Access Compliance Report Public Rights-of-Way (Curb Ramps)

Main Street: ETON_PL Cross Street: ETON_PL Location: NW

ADA ID: RPRK211026143519 Ramp Type: Type 4 - Parallel Initial Pass/Fail: Pass Overall Compliance: No Severity Score: 25

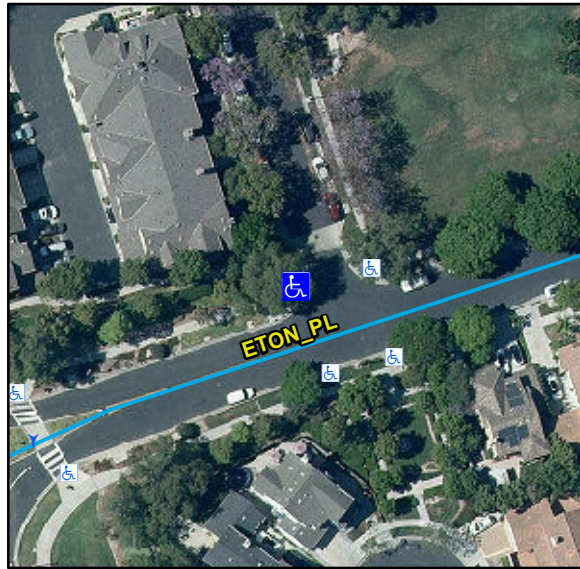
Compliance	Description	Data	Compliance	Description	Data
N/A	Ramp Length LT (in)	128	N/A	Ramp Length RT (in)	90
Yes	Ramp Width LT (in)	90	Yes	Ramp Width RT (in)	124
Yes	Ramp Run Slope LT (%)	0.9	Yes	Ramp Run Slope RT (%)	3.6
Yes	Ramp Cross Slope LT (%)	1.4	Yes	Ramp Cross Slope RT (%)	1.3
N/A	Landing Present	No	No	DWS Provided	No
N/A	Landing Length (in)	N/A	N/A	DWS Contrast	N/A
No	Landing Width (in)	N/A	N/A	DWS Length (in)	N/A
No	Landing Run Slope (%)	N/A	N/A	DWS Full Width	N/A
No	Landing Cross Slope (%)	N/A		DWS Offset Type	N/A
N/A	Landing Movement Obstructed?	No	N/A	DWS Offset Left (in)	N/A
	Landing Movement Type	Curb	N/A	DWS Offset Right (in)	N/A
N/A	Landing Shared	N/A			
N/A	Clear Space	Yes			
N/A	Clear Space To Crosswalk (in)	48			
N/A	Marked Crosswalk 1	No	N/A	Marked Crosswalk 2	No
	Crossing 1 Direction	S		Crossing 2 Direction	E
N/A	Marked Crosswalk 1 Width (in)	N/A		Marked Crosswalk 2 Width (in)	N/A
N/A	Ramp Inside Crosswalk 1	N/A	N/A	Ramp Inside Crosswalk 2	N/A

Crossing 1 Slope (%)	1.2		Crossing 2 Slope (%)	0.7
	Crossing 1 Cross Slope (%)	2.8		Crossing 2 Cross Slope (%)	1.8
Yes	Gutter Ponding	No	No	Curb Slope	11.7
Yes	Gutter Lip Height (in)	0		Road Run Slope (%)	0.1
No	Gutter Run Slope (%)	6.4		Road Cross Slope (%)	7
No	Gutter Cross Slope (%)	3.1	No	Perpendicular Joint Present	No
Yes	Overall Surface Condition	Acceptable			
	Cross Gutter Present?	No		Spandrel Present?	No
	Replace Cross Gutter?	N/A		Replace Spandrel?	N/A

Remove & Replace Curb Ramp With Two New Directional Ramps or Equivalent. Remove & Replace Gutter.
